# MAN<sup>®</sup> Throttle Body changeover to E26 and E32 series

## Bearing shaft extension for new MAN<sup>®</sup> Throttle Bodies

Old MAN<sup>®</sup> throttle body P/N 51.13105-6018

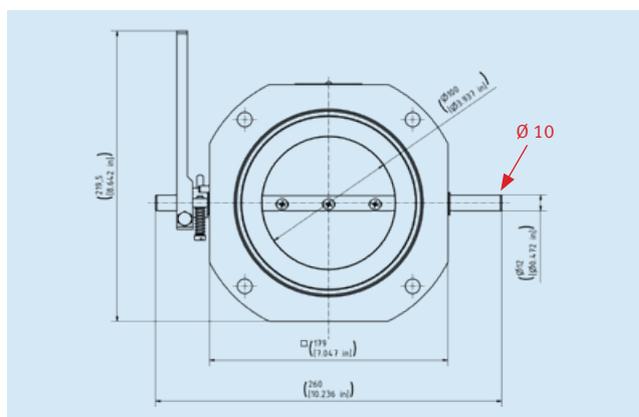
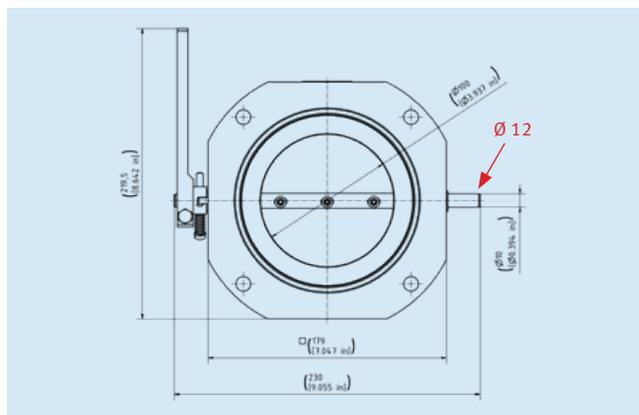
Due to the replacement of the new throttle valve 51.13105-6028 the shaft diameter has been decreased from DM 12 to DM 10 and the length of the bearing shaft has been reduced from 260 mm to 230 mm. This can affect the installation of actuators directly connected to the throttle valve shaft.

For compensation, MOTORTECH offers a shaft extension, so that no design adjustments are necessary.

- Expands the shaft diameter from D 10 to D 12
